Metropolitan Historic Zoning Commission
Sunnyside in Sevier Park
3000 Granny White Pike
Nashville, Tennessee 37204
Telephone: (615) 862-7970

STAFF RECOMMENDATION

1112 Boscobel Street
September 16, 2020

Application: New Construction—Addition and Detached Accessory Dwelling Unit; Setback Determination; Partial Demolition.

Figure 1. 1112 Boscobel

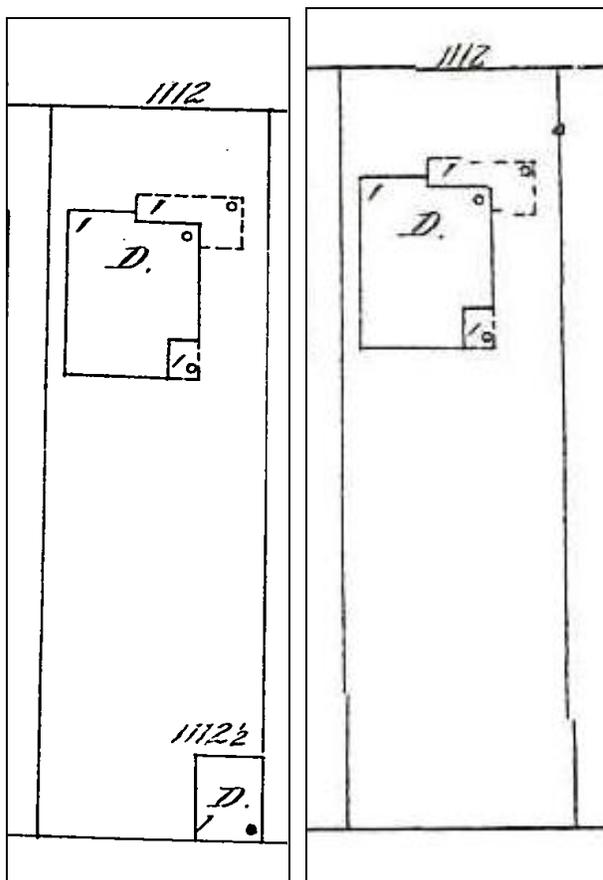
Background: 1112 Boscobel is a c. 1900 Folk Victorian house (Figures 1 & 2). The house appears on the 1908 Hopkins Map but does not appear on the earlier 1889 Hopkins Map. The house has been altered in the twentieth century, most notably with the enclosure of the front porch.

Figure 4. The area at the rear to be removed is marked on this aerial photo.

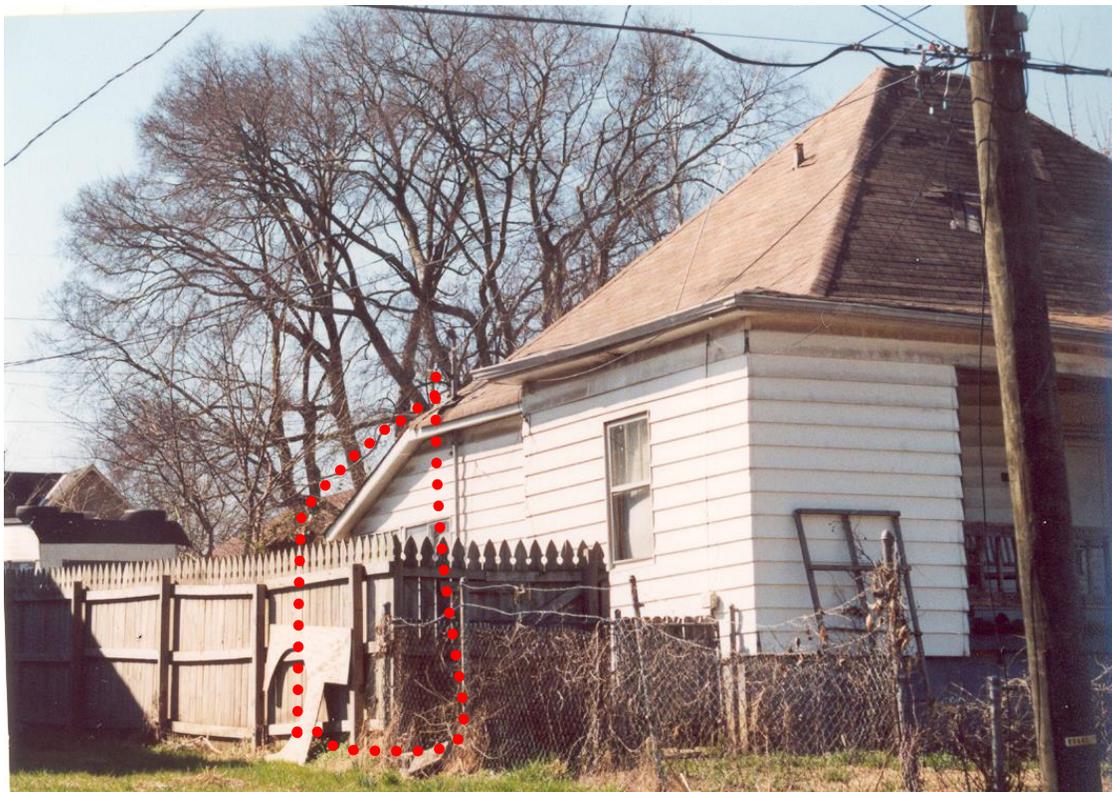
The application also involves removing a rear appendage. Although the rear appendage may be the same area that appears on the Sanborn maps as a partially enclosed area, staff finds that this part of the house does not contribute to the house's historic integrity. It has a lower shed roof form and is located at the rear of the house. In addition, structurally, it has not aged well over the last century. Staff finds that removing this rear appendage will not affect the historic or architectural integrity of the historic house and finds that its removal meets the design guidelines.

SITE PLAN

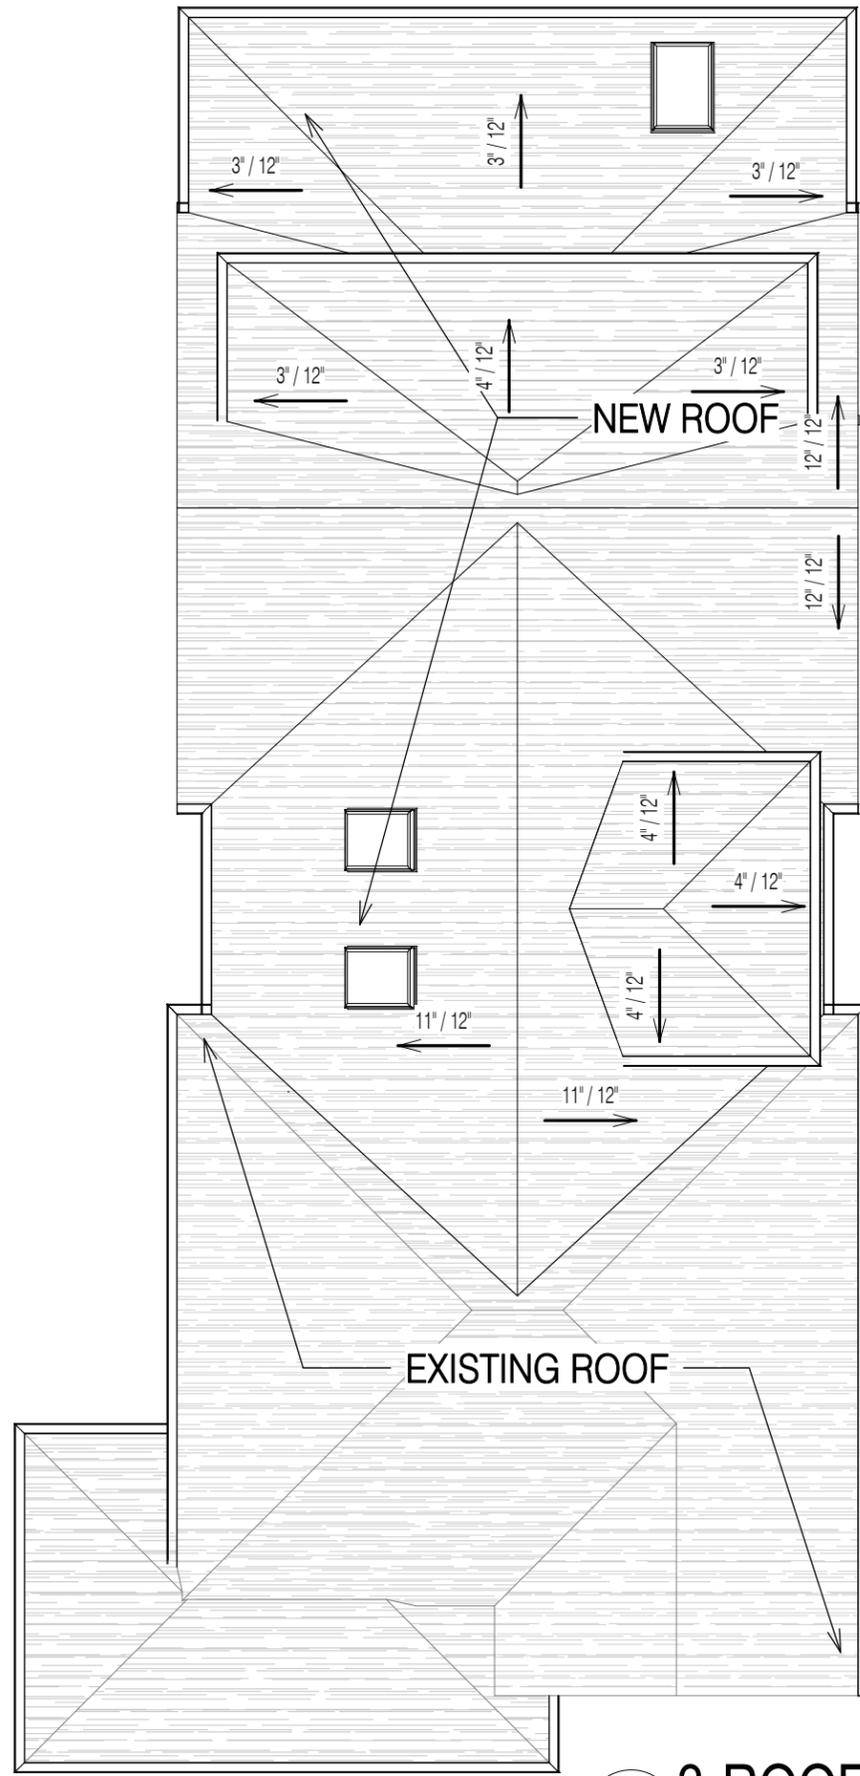
Setback & Rhythm of Spacing: The addition does require a setback determination on the right/west property line. The existing house does not meet the required five foot (5’) side setback on the right/west side. The addition will line up with the historic house and will not be any wider than the historic house. However, because of the placement of the house on the lot, the addition will be approximately three feet, six inches (3’6”) from the right/west side property line at its closest point. Staff finds that this setback determination meets the design guidelines because the addition will be no wider than the historic house and the addition is lining up with the historic house’s side wall, which also does not meet the side setbacks.

On the left/east side, the addition will be approximately eighteen feet from the side property line. It will be over seventy feet (70’) from the rear property line.

Staff finds that the proposed setbacks and setback determination to meet Section II.B.3. and II.B.10. of the design guidelines.

DADU PLANS

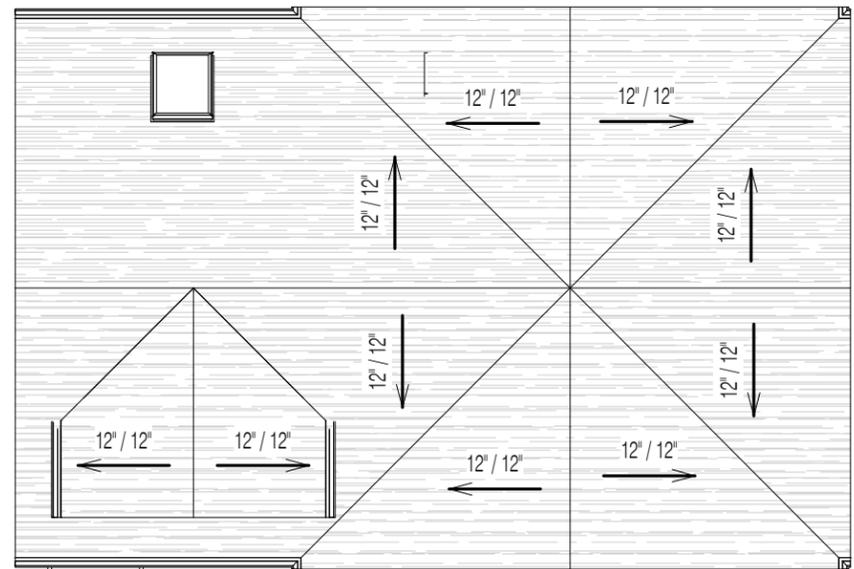
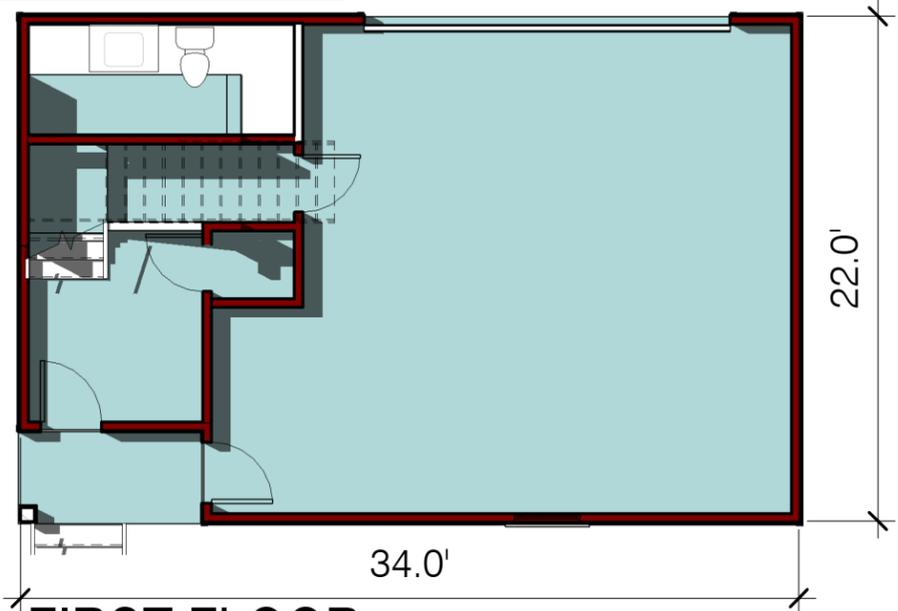
Outbuildings: The applicant proposes to construct a one and one-half story outbuilding at the rear of the property. The outbuilding will include a dwelling unit.

Design Standards: The outbuilding is one and one-half stories and no taller than the historic house. The outbuilding has a simple design that is appropriate for an accessory structure. Staff finds that the proposed design meets Section II.B.8 of the design guidelines.

With final approval of the roof shingle color, windows and doors, and garage doors, staff finds that the known materials meet Section II.B.8 of the design guidelines.
